**PRESTON COUNTY BOARD OF EDUCATION
PRESTON COUNTY, WEST VIRGINIA**

**PROPOSED
WEST PRESTON SCHOOL CLASSROOM RENOVATIONS & CONCESSION STAND**

**ADDENDUM #2
AUGUST 11, 2023**

THRASHER PROJECT #T60-11068

ADD #2
SK-1

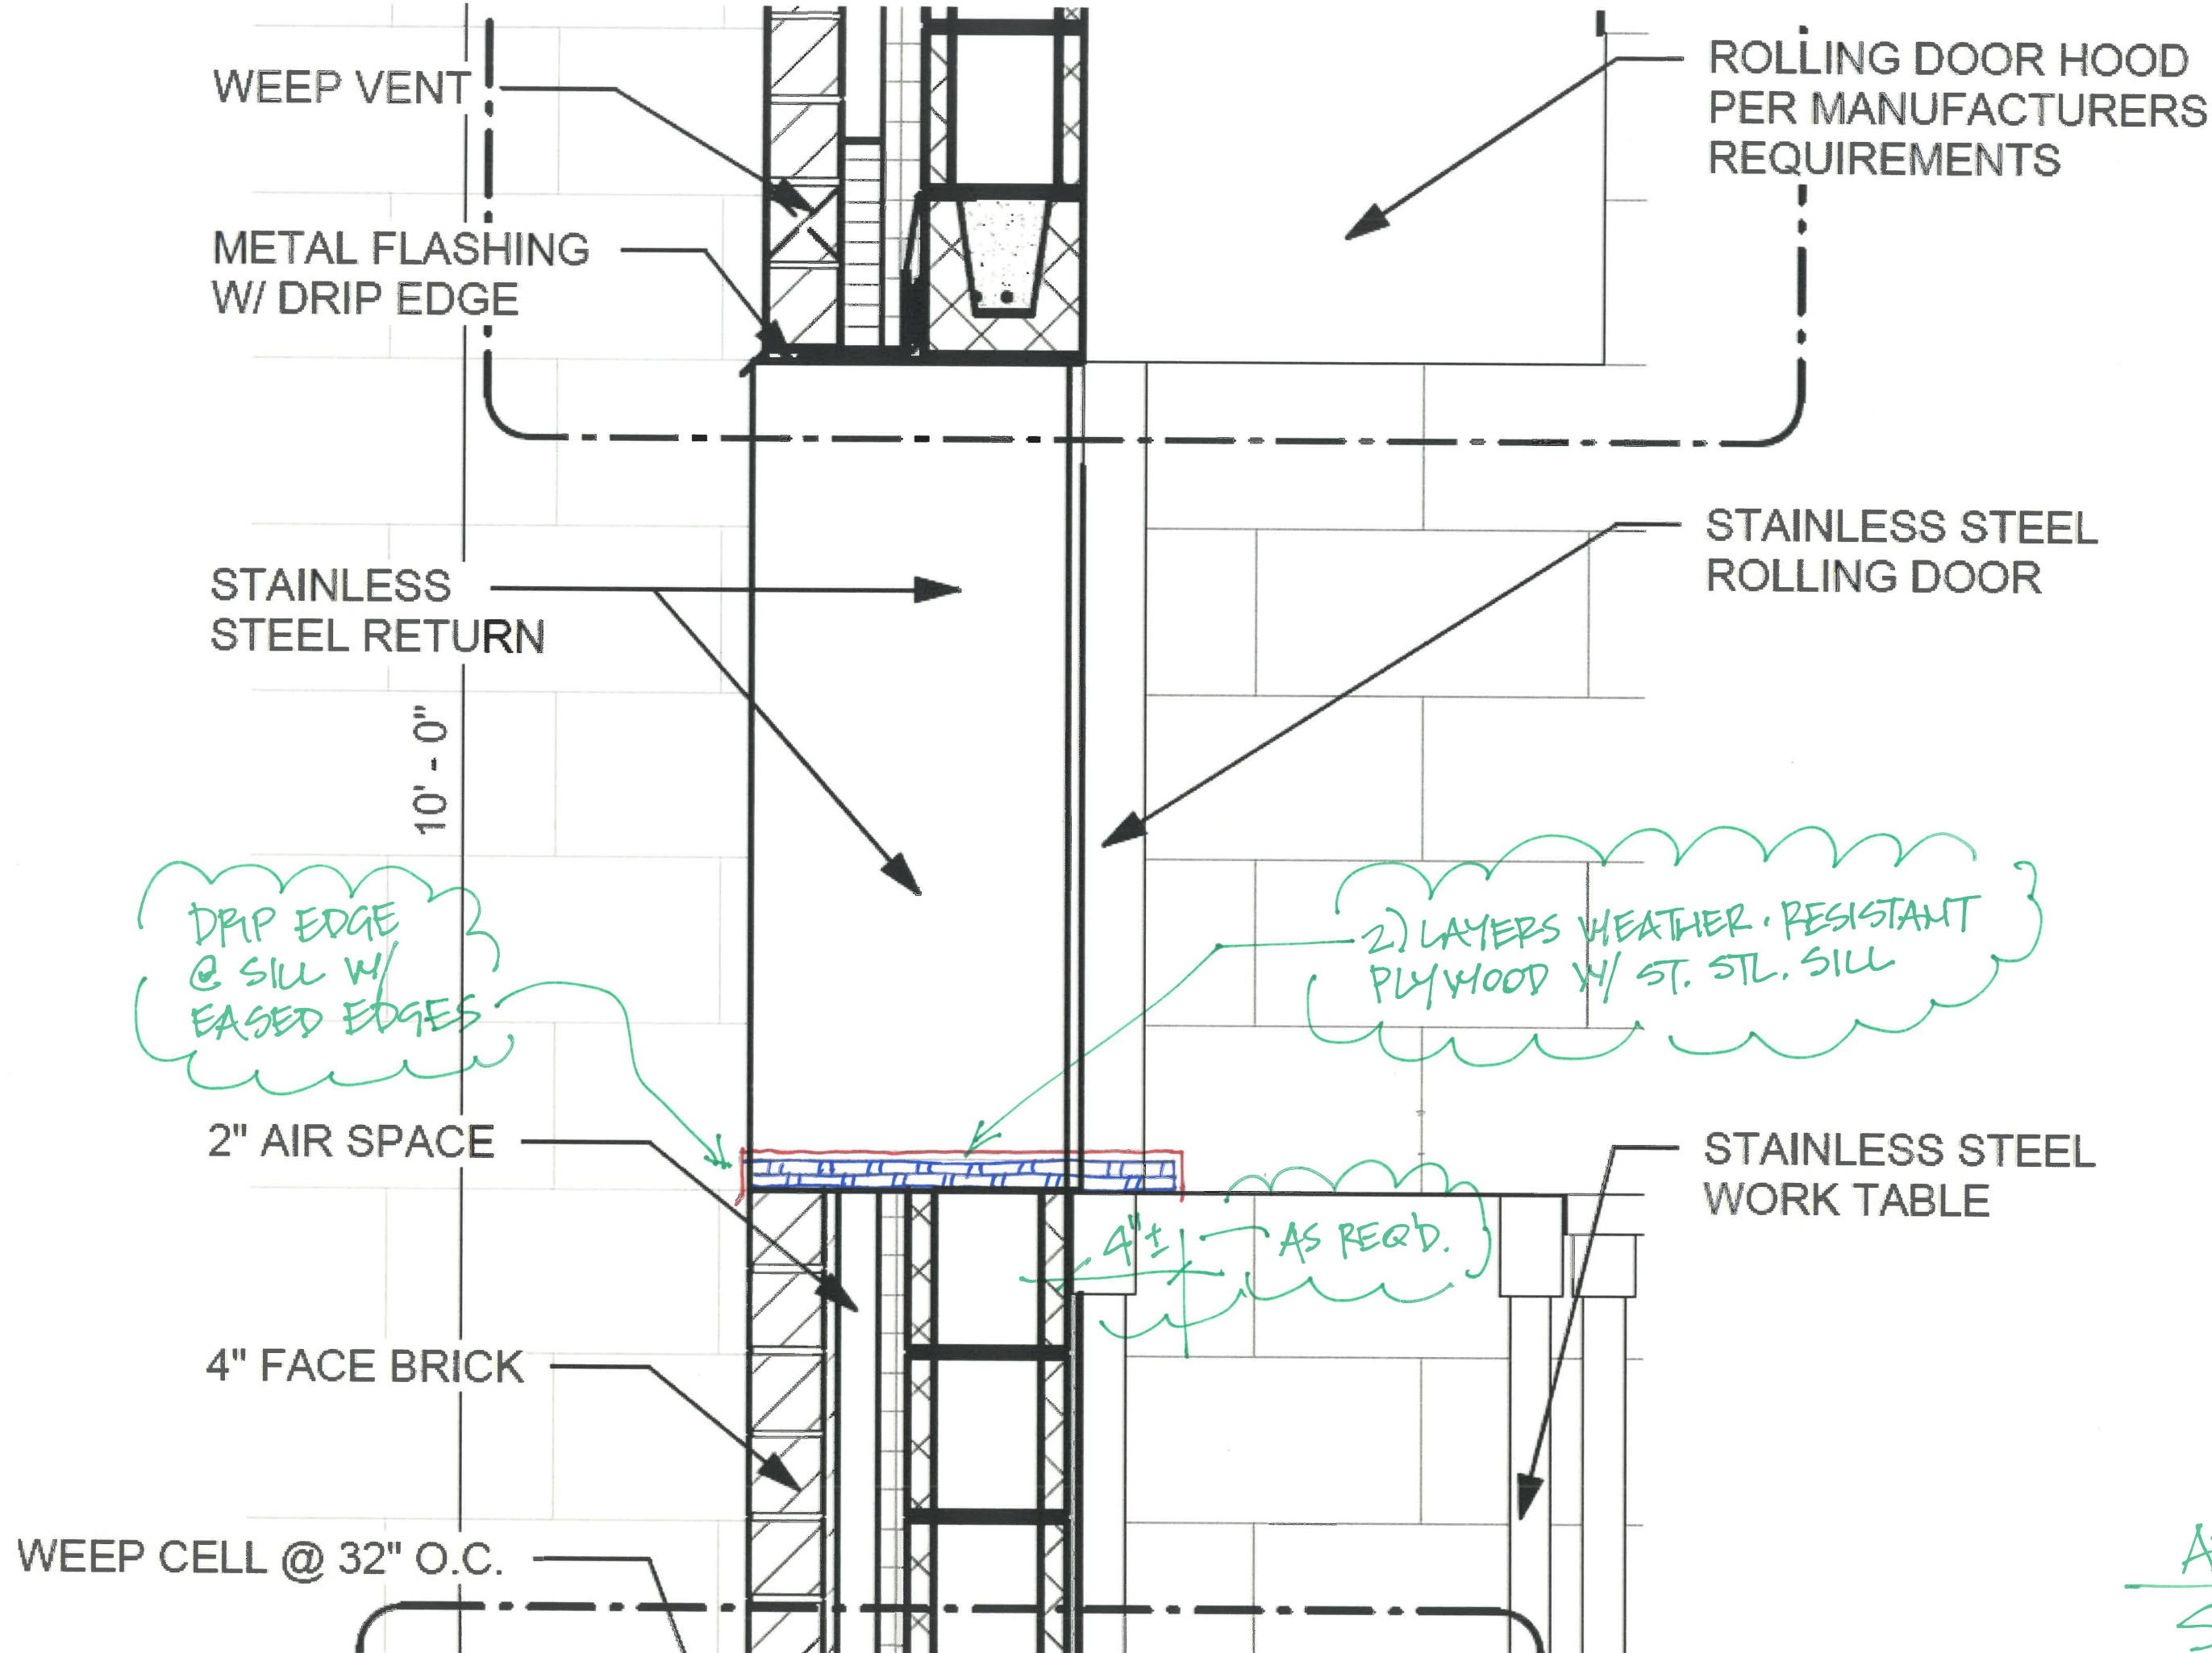
Sheet AB2.01; At Sections 5/AB2.01 and 6/AB2.01, **ADD** information shown on supplemental detail on SK-1 as attached to this Addendum.

QUESTION 4. Drawing AB6.01 – Vendors are not quite sure how to quote the rolling doors. The specs and drawings conflict, please provide direction.

- Q4.1. An integral door, frame, and sill is only possible with a between jamb/under lintel installation. The specs and drawing show a face mounted shutter.

- A4.1. Intent is for Face Mount. See supplemental detail for reference as attached to this Addendum.
- Q4.2. An integral door, frame, and sill is only possible with a between jamb/under lintel installation. The specs and drawing show a face mounted shutter.

- A4.3. Clarifications: Exterior door shall be insulated but not fire rated. Disregard STC requirements. Interior door shall be fire rated but not insulated. Disregard STC requirements.

- Q4.4. One recommendation would be to use a face mounted fire shutter and provide a counter sill with it. The stainless-steel frame would be provided by contractor, not the door company.

- A4.4. Agreed.
